Appendix C

Agency Advice on Applicant's Response Report

**Hume Coal and Berrima Rail Project
Response to the Independent Planning Commission (IPC) report dated 27 May 2019**

Comments on Hume Coal Mine and Berrima Rail Line Projects (SSD 7172 and SSD 7171)

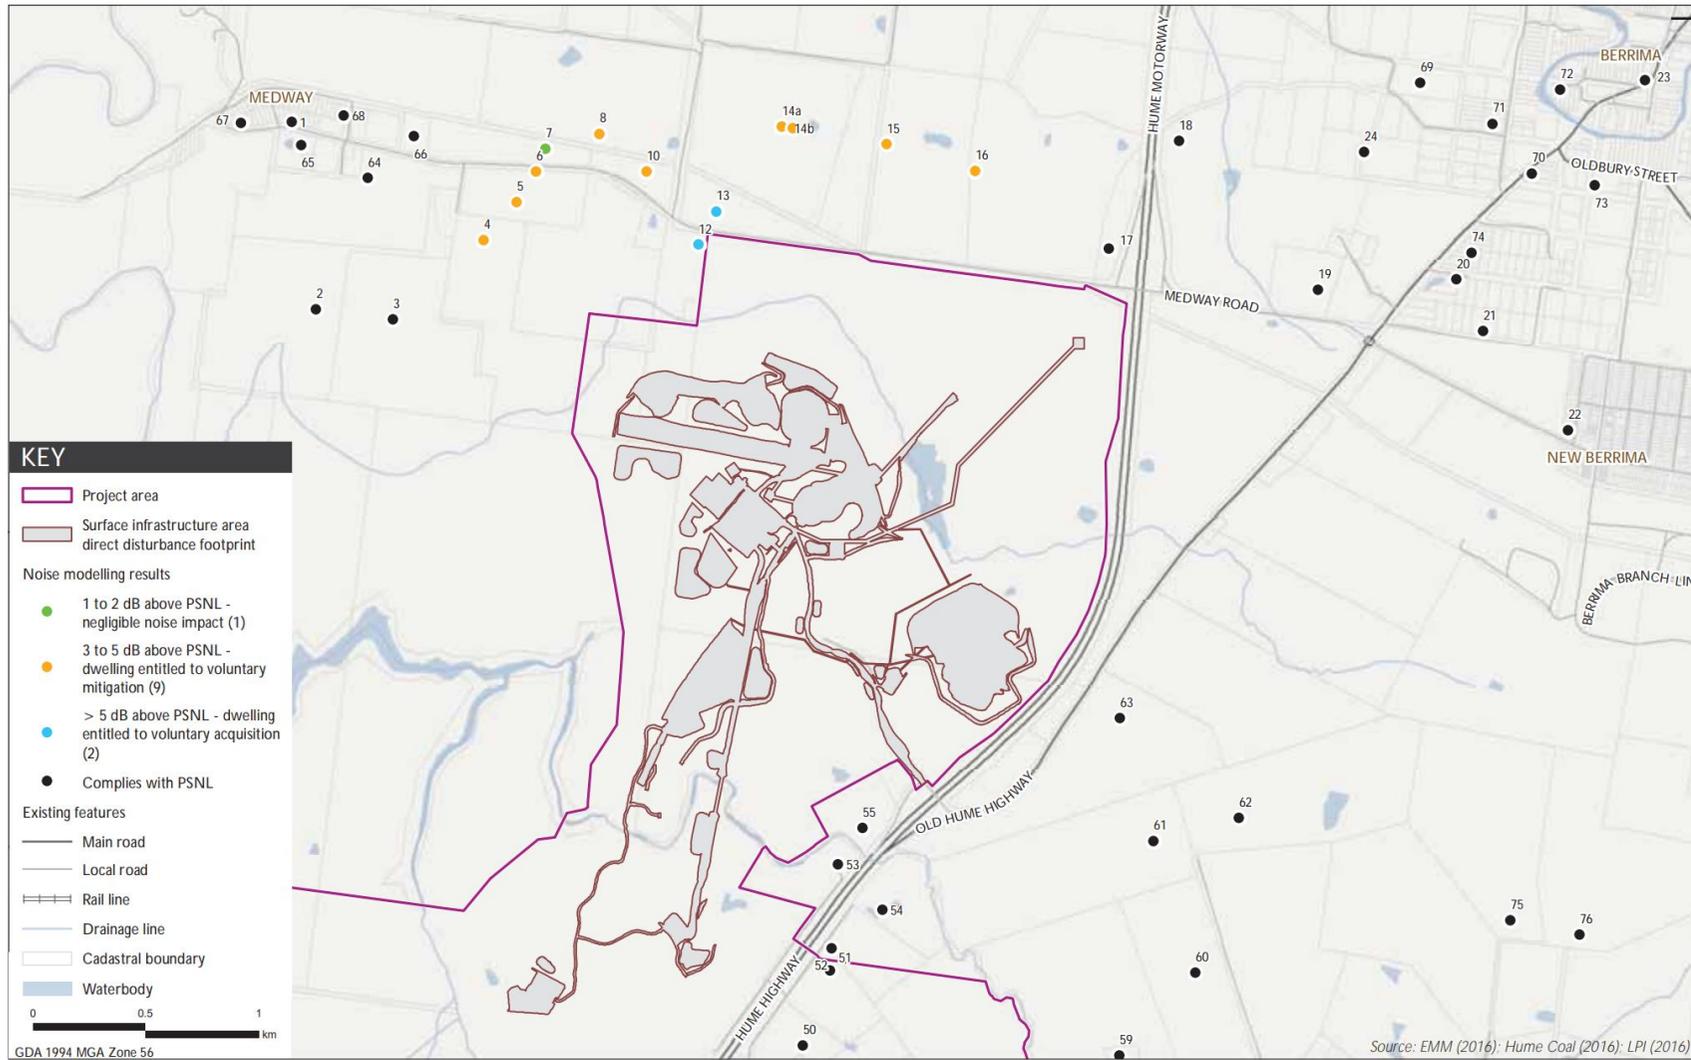
The EPA's review of the original EIS contains a map of affected receivers (attached below from EIS, Volume 7, Appendix I, Noise and Vibration Assessment Report). The map shows that receivers numbered 12 and 13 may be significantly affected by noise and are entitled to voluntary acquisition. There is no receiver location 11. However, Figure 14.4 of the Response to Submissions document shows receiver locations 10 and 11 but no receiver 13.

The EPA recommends that the location of marginally and significantly noise affected properties be clarified in the report and that a revised map be drawn showing the final locations and updated status of noise impacts and VLAMP mitigation.
